## HSCC (I) Ltd

### AMENDMENT –I Dated 02.05.2019

**IFB No. HSCC/PUR/CNCI-Kolkata/Medical Equipment/03/B dt. 12.04.2019**

## B. Name of Item: CT SCAN (128 Slice) Qty: 02 - Technical Query

CONSIGNEE-II

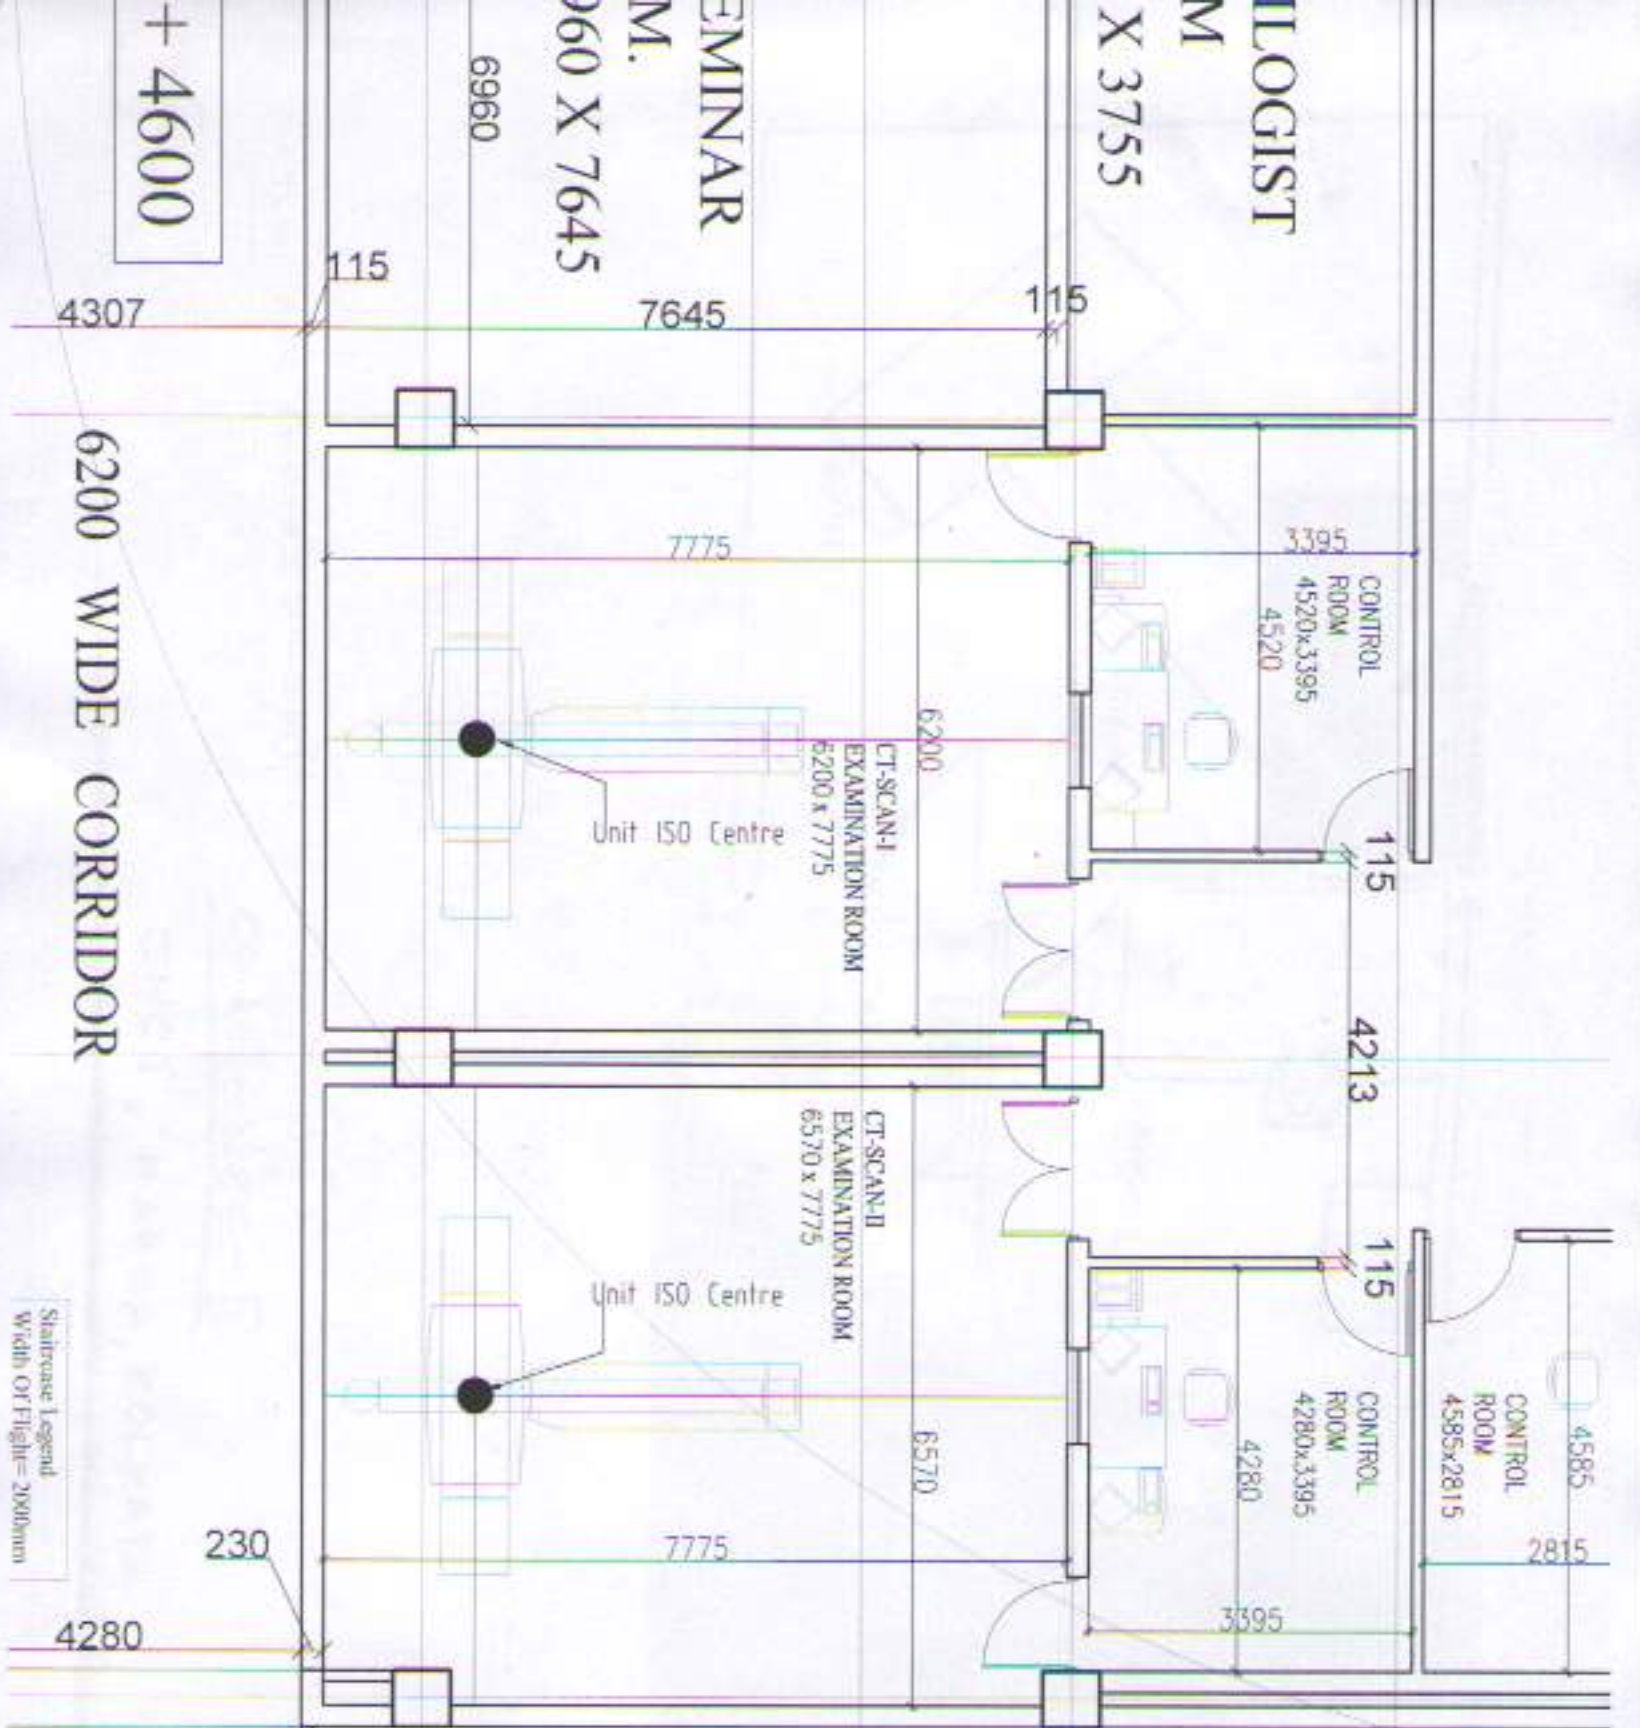
Bidders are requested to quoted in two separate price schedules for each quantity as one CT Scan shall be installed at City Hospital (Hazra (37, S P Mukherjee Road) - with the demolition of existing Room & dismantling of existing C T Scan machine & Installation of New one along with Turnkey) & other shall be installed at New CNCI Campus (Rajarhat - Turnkey as per New Building)
